Report for: Head of Service for Highways and Parking

Title: Minor Works – Batch 2024-04

Report Author/s: Matthew Davies, Principal Engineer - Parking Projects

1.1 To report on the feedback of statutory consultation carried out from 19th February to 12th March 2025 on the proposal to introduce waiting and loading restrictions and parking place changes at various locations across the borough, as detailed in Table 1 Section 7.1.

OUTSIDE 19-21 PALACE ROAD

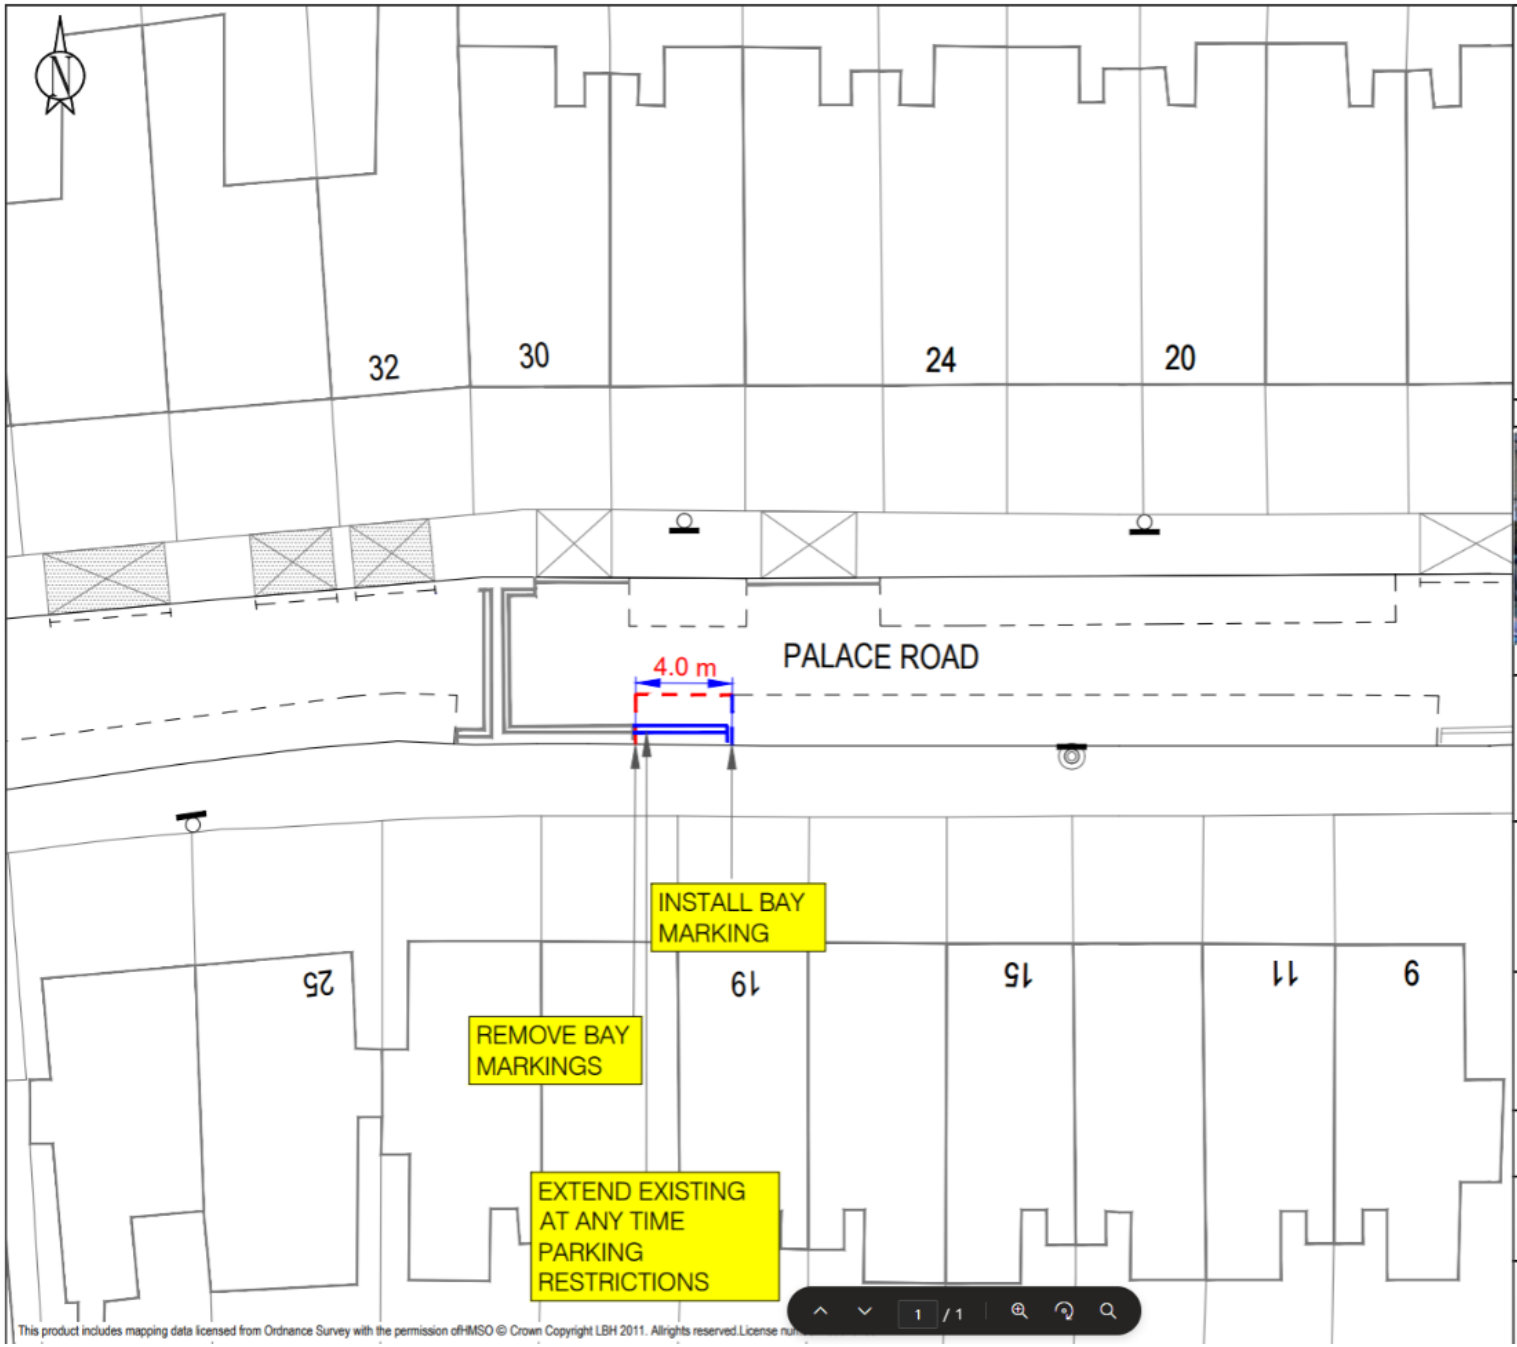
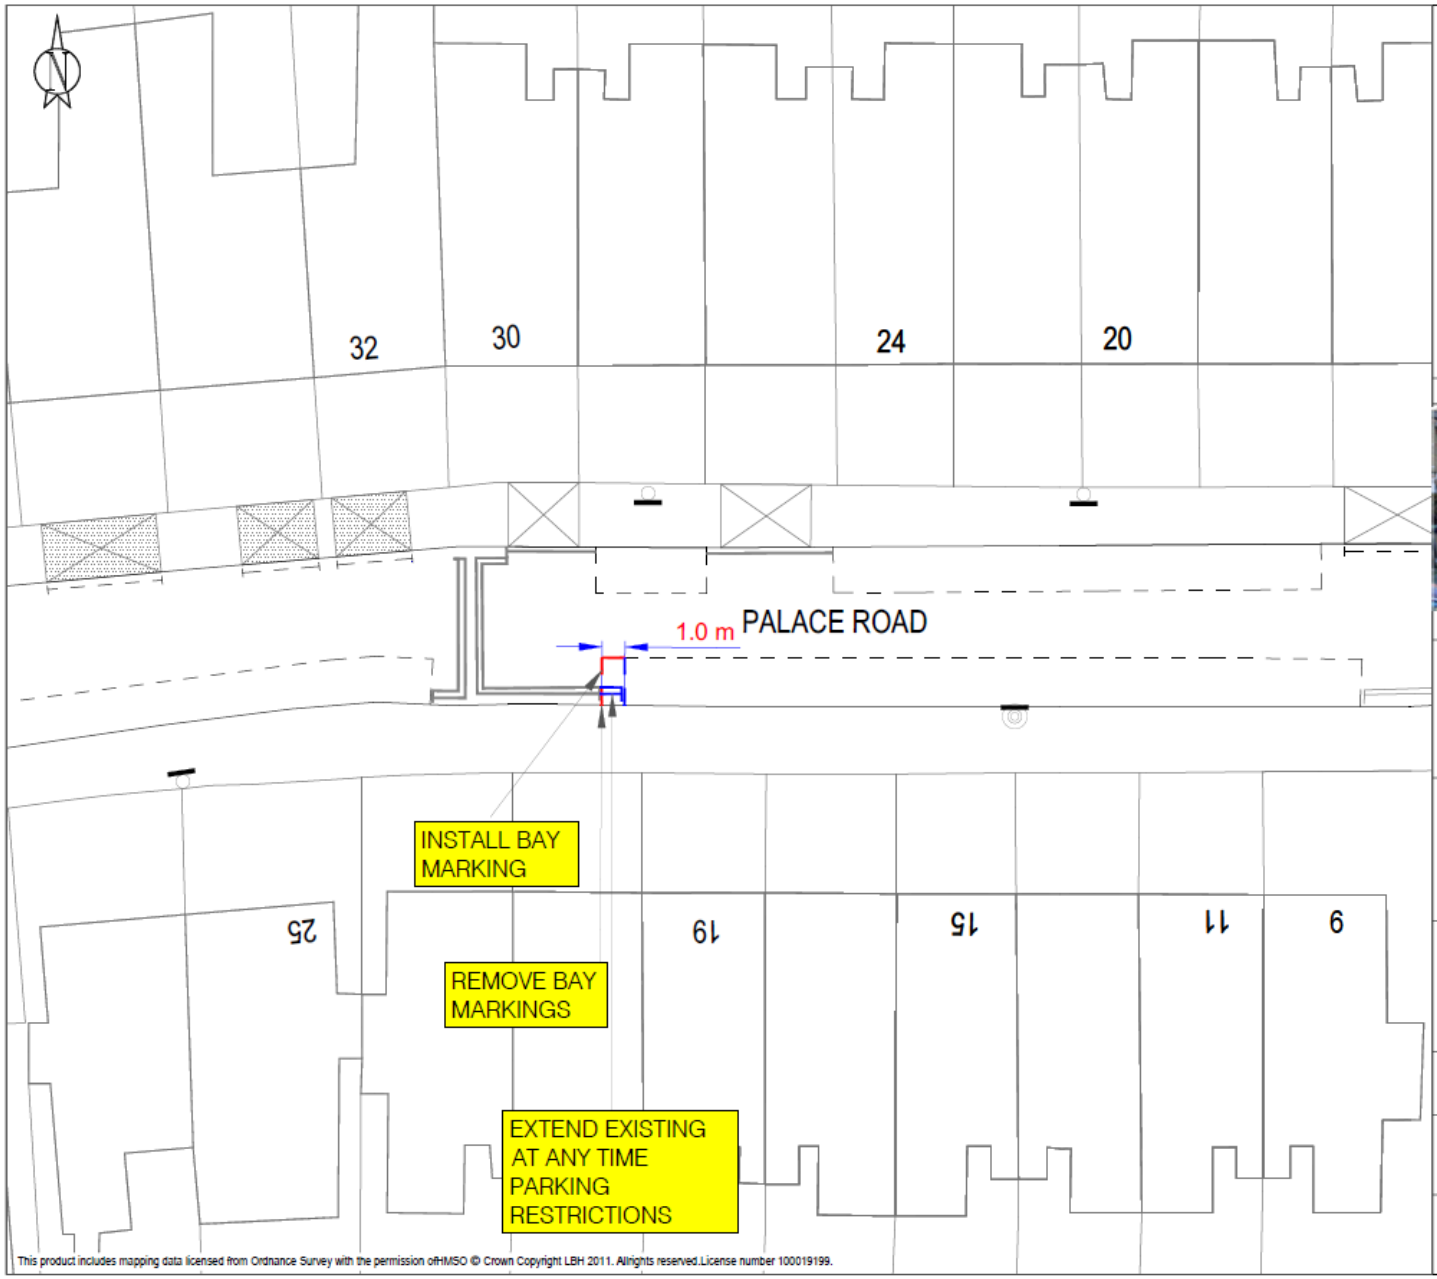
Reference	Response	Officer Recommendation
1) Palace Road N8	Very recently a parking bay was removed next to the barrier opposite to no. 21 and we cannot see the necessity of removing a further 4 metres of parking space	Following further consultation with the resident who originally asked the change, it has been clarified that the request was to only reduce by 1 metre the resident parking bay on opposite side to the resident's property. A revised proposal is

2) Palace Road N8	We strongly object to the removal of parking spaces and placement of double yellow lines outside numbers 19 and 21 on Palace Road, N8. This will reduce the parking spaces and create increased Health and Safety challenges at the barrier outside Number 30 Palace Rd.	Please see response to objection 1 above.

3) Palace Road N8	Extending the double yellow lines by 4 metres is ludicrous and takes away a car space, when they are already frequently under pressure. Mopeds would then be able to speed through, as they now do on the opposite side of the road. There is simply no obstruction and no change needed or wanted.	Please see response to objection 1 above.

4) Palace Road N8	We can't see the rationale for a double yellow line outside no 19 & 21 since we have evidence that cars / vans can reverse & successfully carry out two/three point turns using the space already provided by the existing double yellow lines outside most of 21 even when a car is parked within the bay outside no 19	Please see response to objection 1 above.

5) Palace Road N8	The Council has provided no evidence or reasoned argument as to why the yellow lines in Palace Road should be extended and two parking places removed. Parking places in Palace Road are already at a premium and in 2024 the two parking places opposite 21 and 19 palace road were removed. As a result of this reduction in parking spaces access to private driveways became easier and vehicles were	Please see response to objection 1 above.

Objection 1	I am owner of a house in Palace Road in the permit holders only bay that is due to be shortened. We were part of the group that initially requested the barrier across Palace Road many years ago and it has served its purpose very well over the years, preventing the road from becoming a rat run where cars were speeding dangerously between Park Road and Middle Lane. Very recently a parking bay was removed next to the barrier opposite to no. 21 and we cannot see the necessity of removing a further 4 metres of parking space on what is already a very tight parking area. I have requested an appointment to visit Station Road to see the reasoning behind this new arrangement but have had no response. There is no reason given that I can find on line. It is perfectly possibly to turn a large car or van in the space beside the barrier if necessary and many large vehicles use the area successfully every day. With a wider gap around the barrier motorbikes and electric bikes will be able to cut through at speed with the likelihood of causing a collision. We strongly object to losing more parking space without a given reason/justification.

Objection 2	Consultation Document about the extension of double yellow lines on Palace Rd N8. We strongly object to the removal of parking spaces and placement of double yellow lines outside numbers 19 and 21 on Palace Road, N8. This will reduce the parking spaces and create increased Health and Safety challenges at the barrier outside Number 30 Palace Rd. We could not determine exactly why this request was submitted, so I will speak generally about this area. I am concerned that Haringey has been asked to use its limited financial resources for this change, which, as residents, we do not understand and seems an unnecessary use of vital council funds and its limited resources. We recently lost a parking bay outside number 28 to allow residents to reverse out of their driveway. This new change puts additional stress on parking for residents who are already paying for parking permits for very limited parking places. Those using this driveway, including large vans, have no trouble parking or leaving the property easily. Unfortunately, the rise in the use of delivery motorbikes, electric bikes and electric scooters using this cut-through has compromised this safety. Moreover, some teenagers enjoy repeatedly riding the E-Bikes at high speeds through the gap in the gate for fun, endangering themselves and others. I have helped several children after they clipped the bollards and came off their bikes; luckily, they left without injury. I think the removal of the parking places will create additional empty road space for young people to congregate and gather, creating further problems at this pinch point. Pedestrian safety is a significant concern on this busy walkway used by primary and secondary school children travelling east and west. This issue is especially critical for individuals with pushchairs and wheelchair users on the north side, as they are pushed towards the drop curb adjacent to the bike pathways due to vehicles hanging over the pavement. Additionally, refuse bins are often left on the pavement at the barrier, reducing the accessible width of the pavement and further complicating the situation. This results in a troubling converging point where the Emergency Gate, bike passageway, drop kerb, car overhang, refuse bins and pedestrians moving in both directions converge, posing risks for pedestrians and road users. Our hope is that the road will remain in its current state and that we will continue to enjoy living here.

Objection 3	2024-T56 - Minor Works Batch 4 Resident permit holders parking place (Crouch End 'A' CPZ (CEA)) I Mon-Fri 10:00-12:00 Existing Double Yellow Line extended to include no 19 Palace Road N8 8QL Please note we have emailed TMO (10 days and sent again & telephoned Haringey Council to get specific details about the need for the double yellow lines. However, we have had no response despite Haringey Customer Service providing another email address to the one on the notice, so we can only make assumptions about the request. Generic details on the note are not sufficient to justify the extension of existing double yellow lines. Our objections are as follows: We can't see the rationale for a double yellow line outside no 19 & 21 since we have evidence that cars / vans can reverse & successfully carry out two/three point turns using the space already provided by the existing double yellow lines outside most of 21 even when a car is parked within the bay outside no 19. Please see attached video. The only 'obstructions' are when the refuse is collected – Royal Mail – delivery vans – ambulance service. We have lived in our house for many years – just after the barrier was installed to prevent cars going from Middle Lane to Park Road or vice versa. An excellent TMO. On either side of the barrier are spaces for bikes, motorbikes and mopeds to go through – some travelling through at great speed hence our objection regarding the removal of the parking bay outside no 28 which prevented this happening.. The result is, as predicted, mopeds and specifically Lime bikes going through at alarming speeds. There have been near misses & we hope that there will not be serious accidents something which has happened in Crouch End. However the parking bay outside no 28 was removed so that the resident at no 30 can more easily reverse from their parking space in their front garden. We live at no ## and the removal of yet another parking bay will cause us additional stress / problems when we park. We have had various medical issues in recent years that require us both to drive and a car is essential. We also pay £203 a year for parking between 1000-1200. The unnecessary financial cost should be seriously considered and put to essential safety concerns. In summary we strongly object to the double yellow lines & can only hope that awareness , understanding, equity & a risk assessment, a well as fairness will recognise that the extension of existing yellow lines are NOT required.

Objection 4	extension of yellow lines in Palace Road The Council has provided no evidence or reasoned argument as to why the yellow lines in Palace Road should be extended and two parking places removed. Parking places in Palace Road are already at a premium and in 2024 the two parking places opposite 21 and 19 palace road were removed. As a result of this reduction in parking spaces access to private driveways became easier and vehicles were able to turn in the road by the barrier without risk of damage or accident. There is already a significant difference in the length of yellow lines from the barrier to the start of parking spaces on the south side of the road. The existing yellow lines on the east of the barrier are already considerably longer than those on the west and the current proposals will exacerbate this lack of equity.

We both of us experience mobility problems.. Doubtless the reduction of available parking spaces will worsen my situation.
Objection 5	Resident permit holders parking place (Crouch End ‘A’ CPZ (CEA)) I Mon-Fri 10:00-12:00 As nobody has responded to my wife’s request for details, I must assume this proposal is as a response to a request from a resident, and presumably the same one who has already made previous demands, which have already impinged on our parking. The gap between the barrier and parking bay is 5.5 metres. The “plaintiff’s” car is huge….but still only 1.93 metres wide; surely this is more than enough for any driver. Said person’s car sits daily approx 2 feet onto the pavement. Is that legal? Isn’t the most obvious thing to do is get a smaller car? Additionally, extending the double yellow lines by 4 meters is ludicrous and takes away a car space, when they are already frequently under pressure. Mopeds would then be able to speed through, as they now do on the opposite side of the road. There is simply no obstruction and no change needed or wanted.

3.4 Approve the implementation of a revised proposal for Palace Road as shown in Appendix 2. The revised proposal reduces the parking bay by 1m instead of 4m which will result in no loss of parking.

Reference	Response	Officer Recommendation
	on what is already a very tight parking area. We strongly object to losing more parking space without a given reason/justification.	therefore recommended for implementation, which will preserve the current parking capacity. The bay will continue to accommodate six resident vehicles, ensuring no loss of parking for local residents.

REDUCE BAY MARKINGS BY 1 METRE,
INSTALL NEW BAY MARKING
EXTEND EXISTING DYL
